California State Polytechnic University, Pomona

Master Plan Update

Updates to MP Advisory Committee + Transportation Committee

12 September 2018

Concept 03: Make a Big Leap

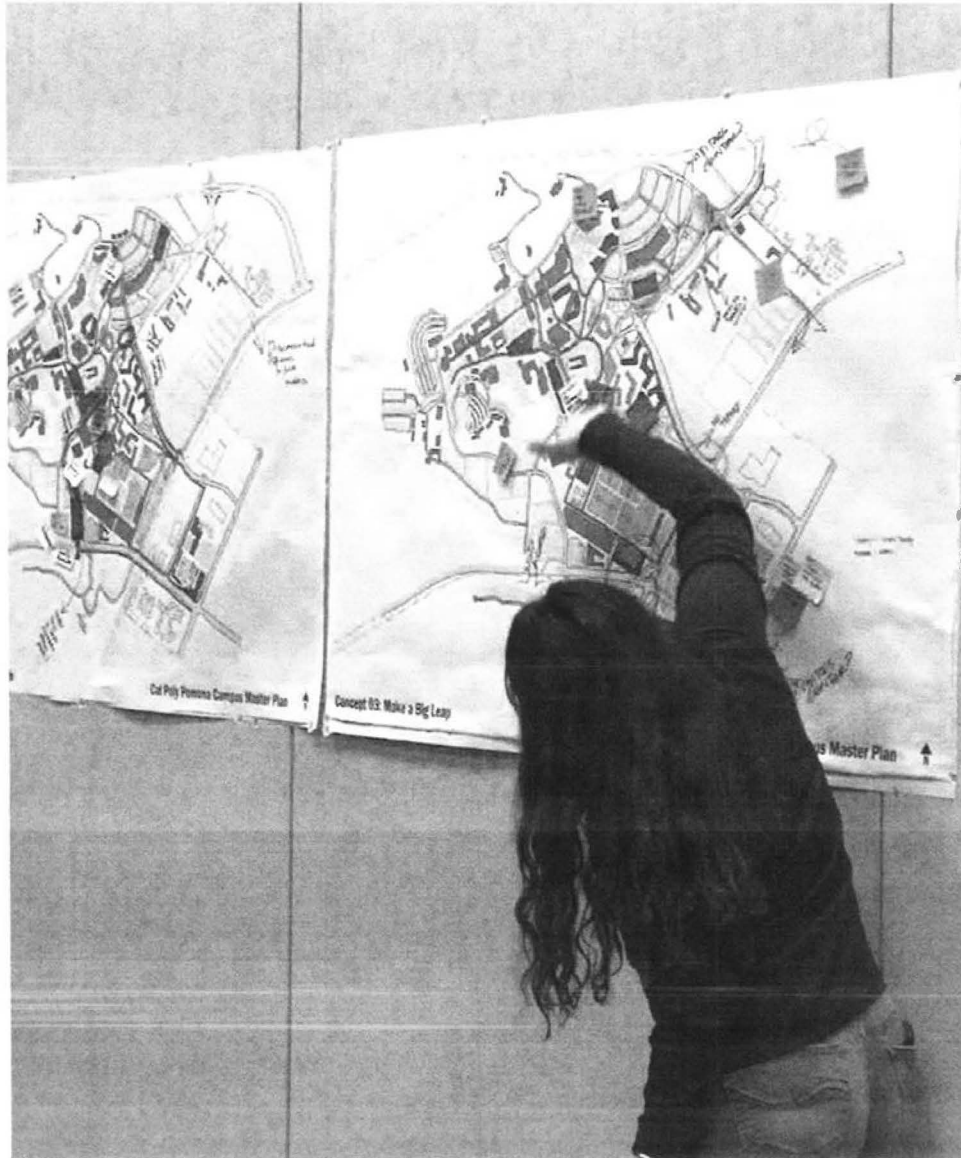
- **N-S pedestrian + bike mall** (*w/o transit, extend across SC Dr*)
- **One-way campus shuttle bus loop**
- **University Drive extended to South Campus Drive**
- **New Arena-Fieldhouse development in Innovation Village**
potential to be a 'Visitors/Alumni Center, street front retail/food/entertainment extends Brew Works concept to create an active 'town-gown' edge
- **Campus Health + Well-being Center on the central mall**
(some concern about distance from the academic core)

- **Child Care Center location** - *parents still have to look for parking after drop-off.*
- **Transit hub located at Temple and S. Campus** - *needs a pedestrian bridge for safer access to the campus and surrounding housing, etc.*

Overall this concept seems to be more forward looking, connecting to the south campus and creating a new major front-door-gateway at Valley and Temple.
